## COUNCIL ASSESSMENT REPORT

### NORTHERN REGIONAL PLANNING PANEL

<b>PANEL REFERENCE &amp; DA NUMBER</b>	PPSNTH-293 – DA2024-141.1
<b>PROPOSAL</b>	Recreational Facility (Outdoor) and Recreational Facility (Indoor) and Kiosk - Port Macquarie Aquatic Facility (as described in Schedule 1)
<b>ADDRESS</b>	<p>LOT: 14 SEC: 16 DP: 758852, LOT: 18 SEC: 16 DP: 758852, LOT: 6 SEC: 16 DP: 758852, LOT: 19 SEC: 16 DP: 758852, LOT: 16 SEC: 16 DP: 758852, LOT: 5 SEC: 16 DP: 758852, LOT: 20 SEC: 16 DP: 758852, LOT: 7 SEC: 16 DP: 758852, LOT: 17 SEC: 16 DP: 758852, LOT: 8 SEC: 16 DP: 758852, LOT: 9 SEC: 16 DP: 758852, LOT: 15 SEC: 16 DP: 758852, LOT: 2 DP: 808449, LOT: 7063 DP: 1040735, LOT: 1 DP: 808449.</p> <p>Gordon Street PORT MACQUARIE, Munster Street PORT MACQUARIE</p>
<b>APPLICANT</b>	Co.op Studio Pty Ltd
<b>OWNER</b>	Council Managed Crown Land
<b>DA LODGEMENT DATE</b>	14 March 2024
<b>APPLICATION TYPE</b>	Development Application
<b>REGIONALLY SIGNIFICANT CRITERIA</b>	Section 2.19(1) and Clause 3 of Schedule 6 of <i>State Environmental Planning Policy (Planning Systems) 2021</i> declares the proposal regionally significant development as the proposal is Council related development with an e

**Figure 14 – Elements of the proposal above the 11.5 m height limit**

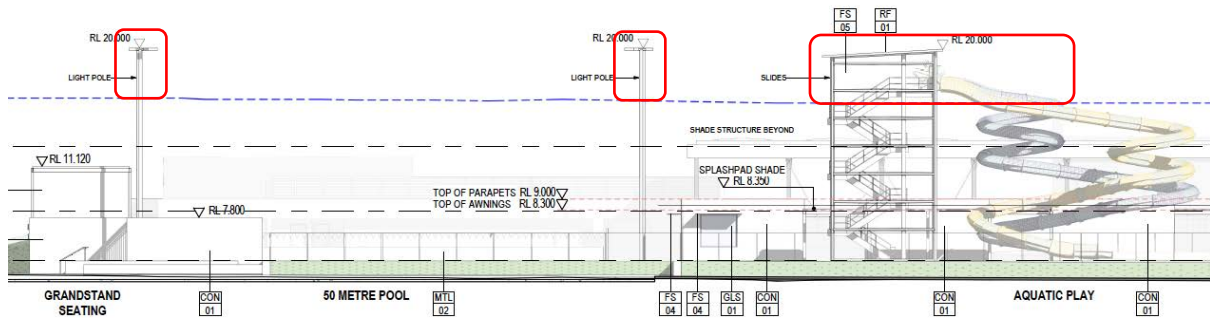
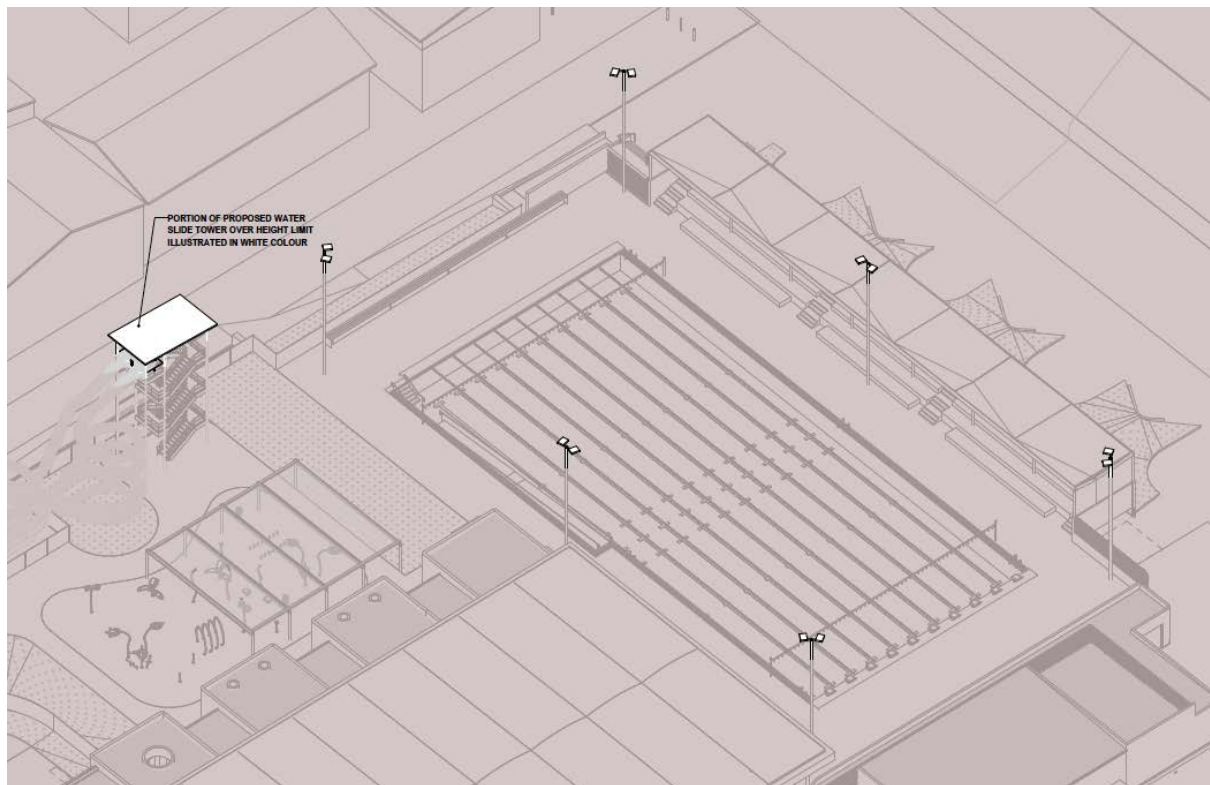
Clause 4.3(2) of the LEP references a Height of Buildings Map, which specifies a maximum height of 11.5 metres for the subject site. A majority of the proposed development is below the maximum height limit; however, several elements breach this by up to 4.6 metres, these being the waterslide tower, a small portion of the water slides, and the top section of flood light poles, as indicated in Figures 14 and 15 below.

**Figure 15 – Portion of water slide tower, water slides, and light poles above the 11.5m height limit**

The Written Request is considered to satisfy Clause 4.6(3)(b), providing sufficient environmental planning grounds to justify contravening the maximum height limit.

**Figure 19 – Neutral coastal lifestyle theme, with muted, recessive tones that blend into the natural environment and provide low maintenance, durability, and sustainability**

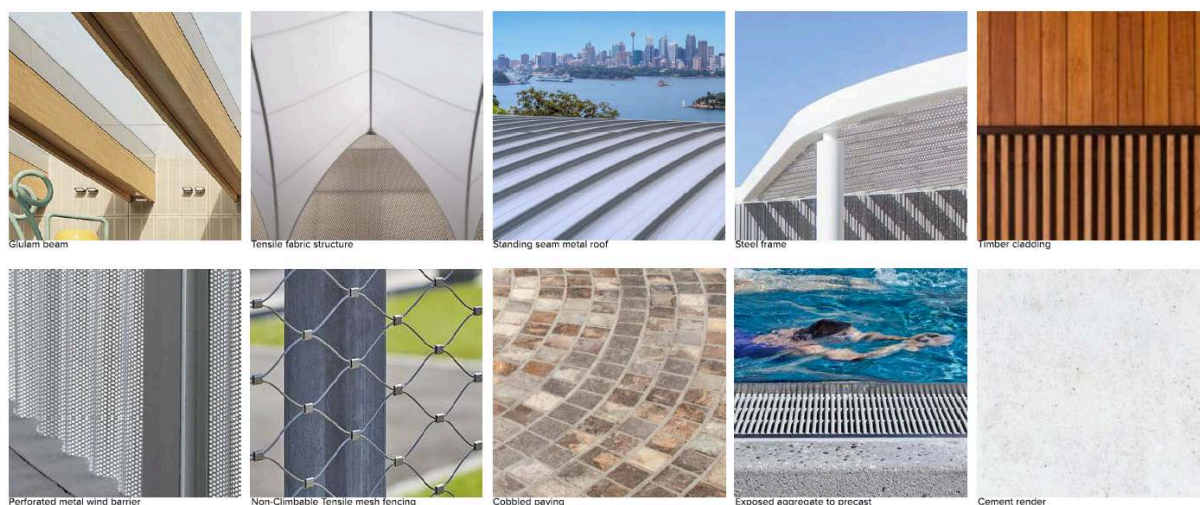
Concern was initially raised about the presentation of the grandstand to Gordon Street, including treatment of the solid wall facing the street, detail of shade structures, and how unwanted access to the facility from the would be deterred from the three mounds landscape feature.

The applicant has since provided additional detail and clarification of the Gordon Street presentation. It is proposed to use precast concrete panels for the base of the grandstand but soften this with:

- public art, graphics, and/or local storytelling to add interest;
- the three mounds to represent the Three Brothers Mountains to be extensively landscaped to deter access and be situated 1.5m from the grandstand wall so as to limit the ability to climb the grandstand wall.
- Use of non-climbable tensile steel mesh infill to steel canopy to provide security but allow views through the site and passive surveillance of the street and landscaped frontage.
- Provision of informal seating in front of the three mounds to cater for gathering before and after large events and for community engagement at other times.

The final presentation is shown in Figures 16-19 below and is considered to offer a balance of hardscape, landscape and indigenous interpretation, community engagement, security, and surveillance. The overall theme of the facility is neutral coastal lifestyle, with muted, recessive tones that blend into the natural environment and provide low maintenance, durability, and sustainability.
